## **PROPOSED AMENDMENTS TO SMALL FAMILY APARTMENT (SFA) AWHO PROJECT AT COIMBATORE**

1. Further to our update dt 11 Mar 2016.
2. A proposal to shift the main door (entrance door) to outer periphery and straighten the offset, has been received. The same has been analysed vis-à-vis the original plan. The advantages & disadvantages of Revised Plan (Option 1) and Original Plan with slight modification (Option 2), along with the drawings are given in succeeding Paras :-

# Sketch 'Q'

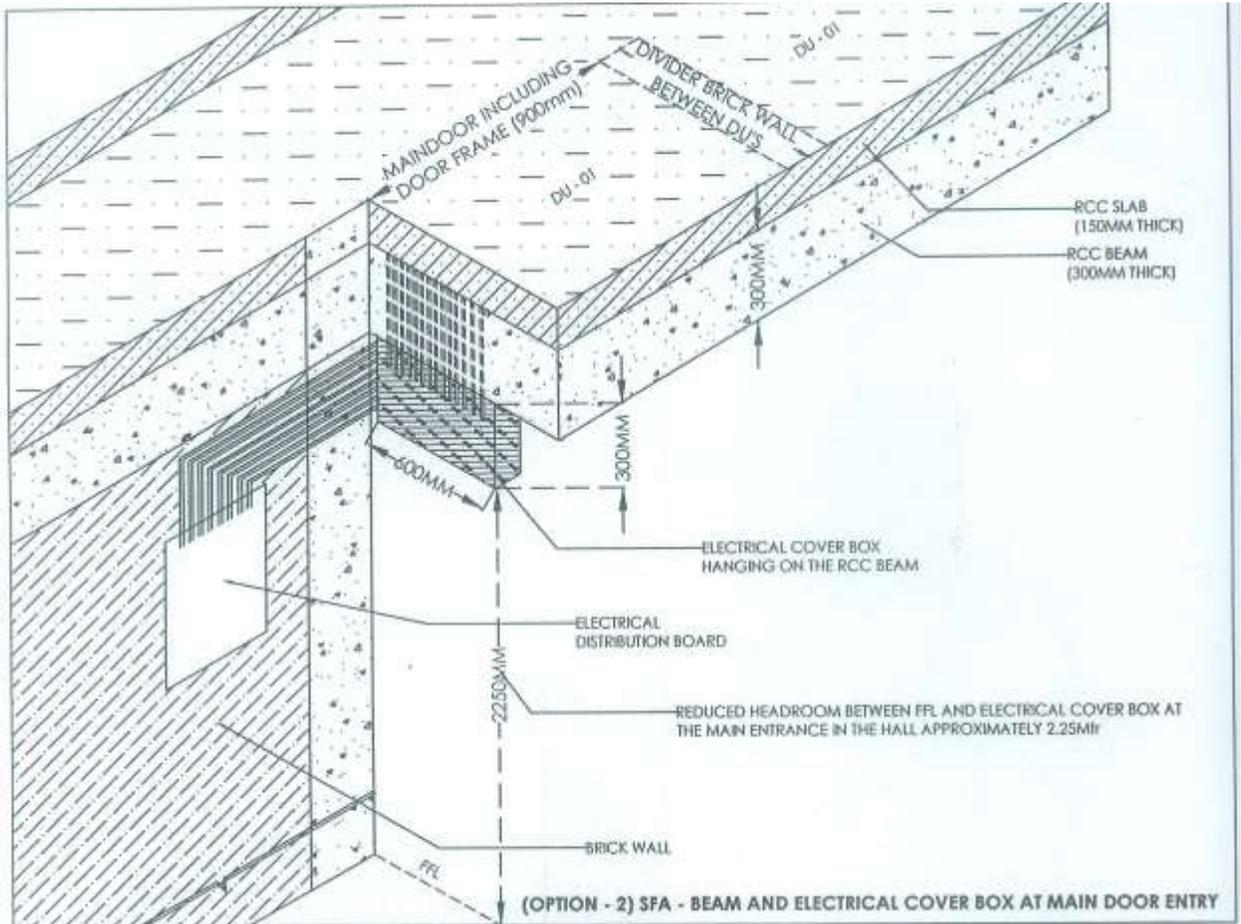
- (iv) The electrical junction box is to be shifted. The conduits which are already laid through concrete slab and beams will have to be diverted along the bottom of the beam and taken to new location as shown. The conduits cannot be concealed along the beam, which will be very unpleasant sight and is aesthetically unacceptable (Refer sketch 'Q').

# Sketch 'R'

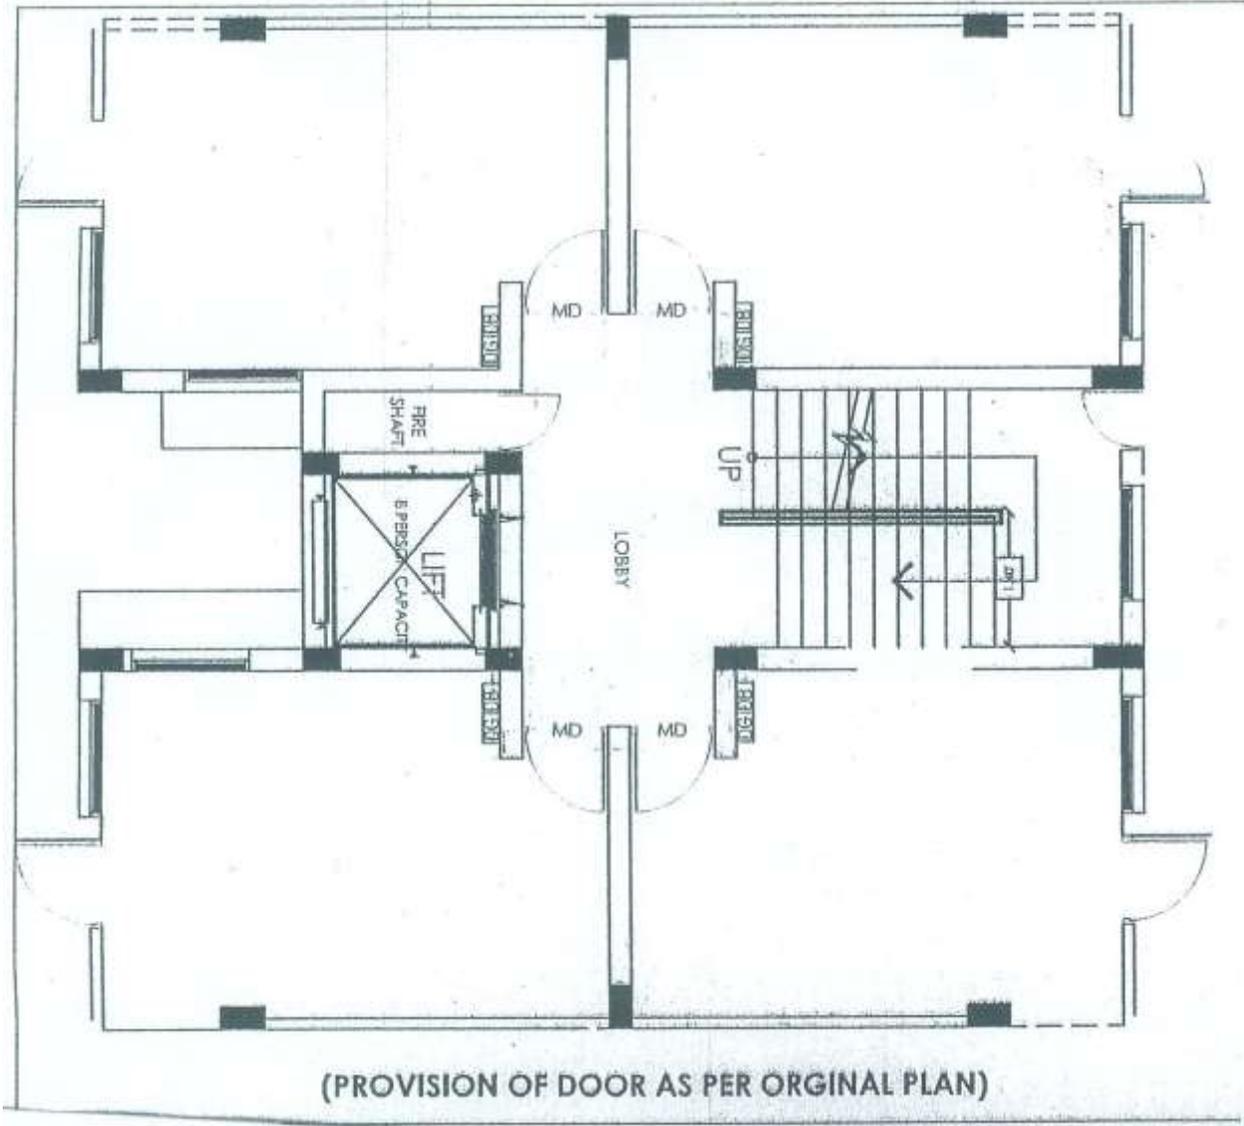
- (v) Any person using the lift or staircase will be able to get a peak view in to the house.
4. Option 2 (Original Plan with Slight Modification) (Sketches 'R' & 'S' refers).

- (i) Wider main door which is aesthetically appealing and is technically a necessity.
- (ii) Door is away from the left door/stairs.
- (iii) Presents direct view into the house, giving privacy.
- (iv) Conduits are not exposed or no artificial covering need to be given.
- (v) Beams are not exposed inside the house. Hence, pleasant view.
- (vi) No need of shifting of conduits. Hence no need of covering the conduits as beam by artificial means. Thus giving better look.
- (vii) Any repairs inside the concealed conduits along the beam, the artificial covering will have to be removed leading to recurring expenses.
